***ADDENDUM # 003***

**Our Lady of Fatima  
545 Baldoon Rd  
Chatham, ON**

**Mechanical & Washroom  
Renovations  
Project No. 619-CP1825**

**Wilson Diaz Architects Inc.**  
280 Queens Ave, Suite 1Q  
London, Ontario  
N6B 1X3

PROJECT TITLE <b>OUR LADY OF FATIMA PHASE 2 RENEWAL</b>		DRAWING TITLE <b>CHILDCARE DOOR &amp; WINDOW</b>	
SCALE <b>1 : 200</b>	DRAWN BY <b>SH</b>	CHECKED BY <b>RW</b>	Reference Page No. <b>AD100, A100</b>
DATE <b>5/8/2018</b>	PROJECT No. <b>1724</b>		DRAWING No. <b>ASK-012</b>

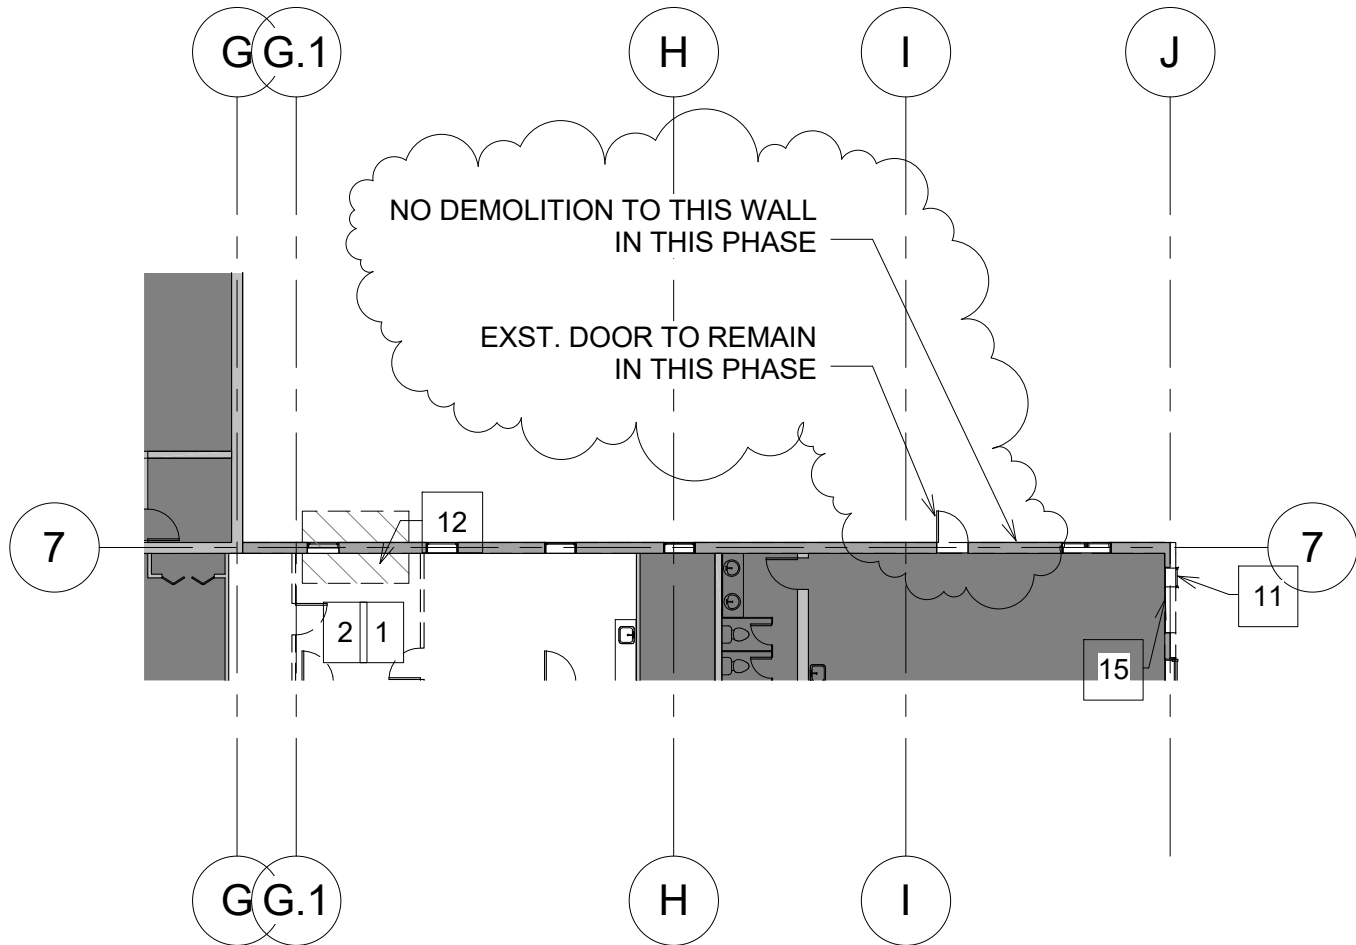
**5. ASK-012 – Childcare Door & Window**

Remove door D114 from schedule and scope of work. No demolition work to be done on wall in sketch ASK-001 from Addendum #001 in this phase.

REMOVE DOOR D114 FROM DOOR SCHEDULE AND SCOPE OF WORK

DRAWING No.  
ASK-008

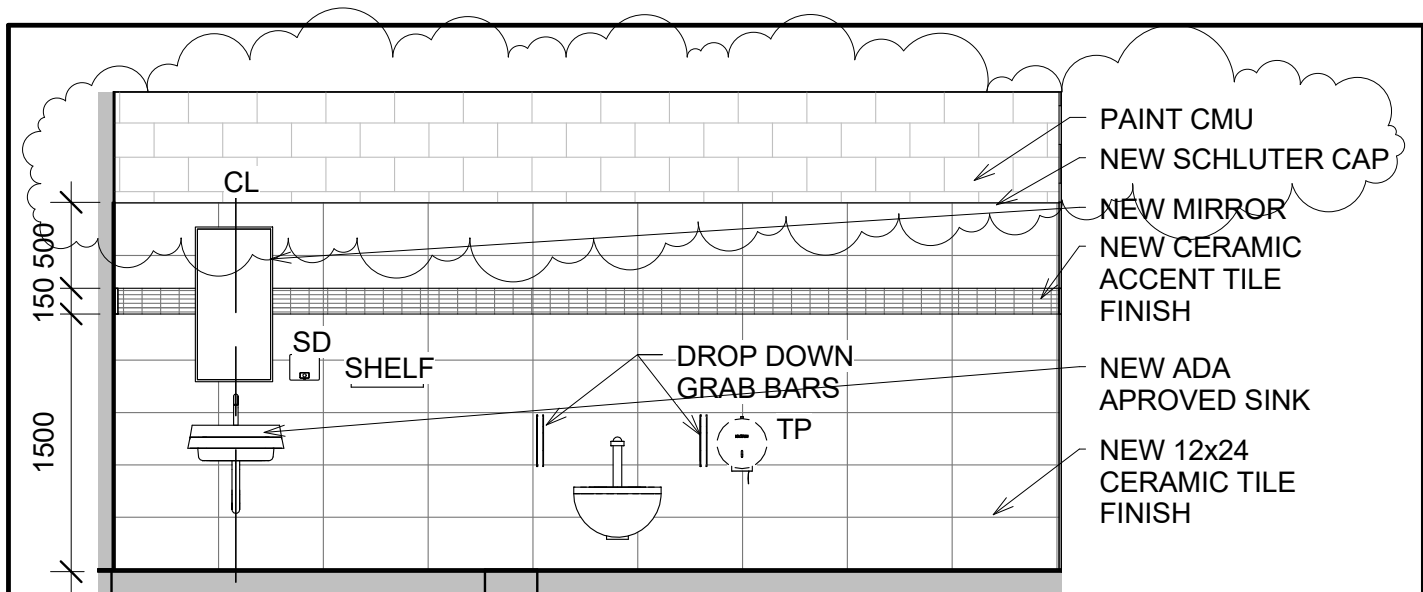
- 1. ASK-008 – Part Demolition Plan (AD/100)**  
Cut opening in roof membrane, rigid insulation and metal deck to allow for rooftop condensing unit ducts to penetrate into building. Refer to mechanical drawings for CU section (1/M102) and roof curb detail.
- 2. ASK-009 – Universal Washroom Elevation**  
Wall tile to be installed 2150 up Universal Washroom walls and capped with Schluter edge.
- 3. ASK-010 – Universal Washroom Elevation**  
Wall tile to be installed 2150 up Universal Washroom wall North Wall and capped with Schluter edge. East wall will not have any wall tile and will instead be painted concrete

CUT OUT SECTION OF ROOF  
MEMBRANE, RIGID INSULATION  
AND ROOF DECK TO ALLOW FOR  
NEW CONDENSING UNIT DUCT DROPS

ROOFTOP CURB AROUND NEW  
CONDENSING UNIT. REFER TO  
MECHANICAL DWGS (M601) FOR CURB  
SECTIONS AND DETAILS (1/M102).

PROJECT TITLE <b>OUR LADY OF FATIMA PHASE 2 RENEWAL</b>			DRAWING TITLE <b>UNIVERSAL WASHROOM ELEVATIONS</b>	
SCALE <b>1 : 40</b>	DRAWN BY <b>SH</b>	CHECKED BY <b>RW</b>	Reference Page No. <b>A850</b>	
DATE <b>5/8/2018</b>	PROJECT No. <b>1724</b>		DRAWING No. <b>ASK-009</b>

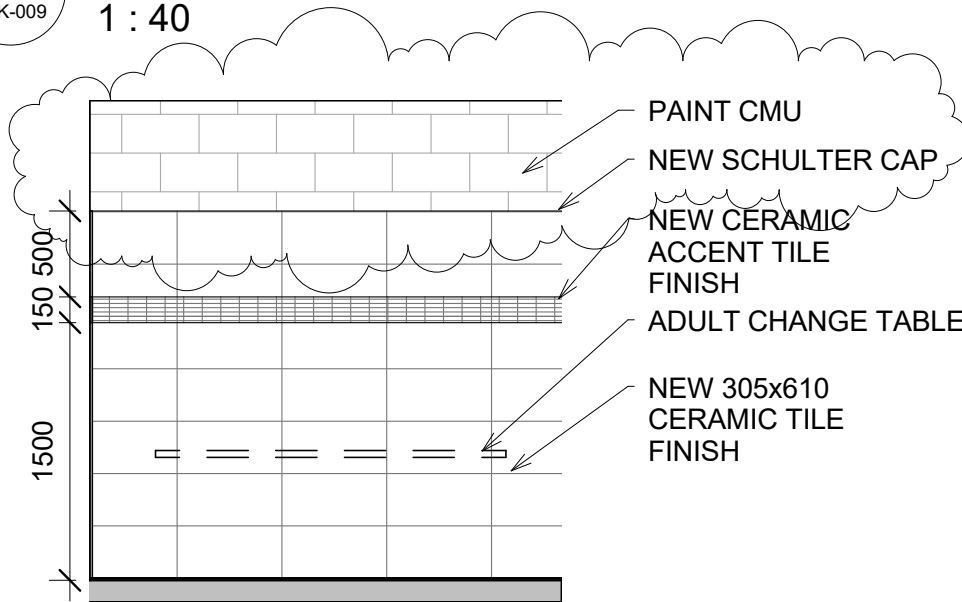
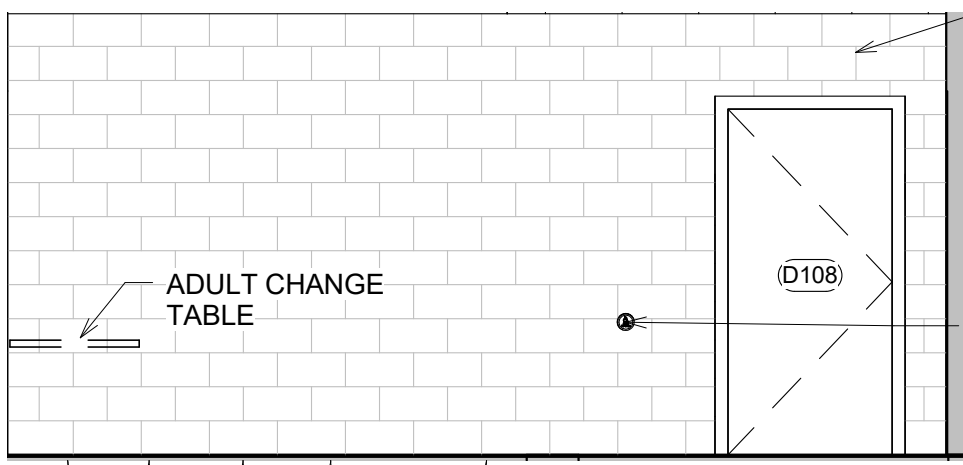
- c. Question: On drawing A850, elevations 5, 6 and 8, the note indicates New Schluter Cap at wall tile grout lines.

I understand installing the New Schluter Cap on the top edge where the wall tile stops and does not go all the way to ceiling.

Please let me know if the New Schluter Cap is typical at all Ceramic wall tile in lieu of wall tile grout at the Universal Washroom.

Answer: New Schluter Cap should only be installed where the wall tile stops. The universal washroom elevations have been revised as per the attached architectural sketches ASK-009 and ASK-010 showing wall tile installed 2150mm up wall with Schluter edge cap.
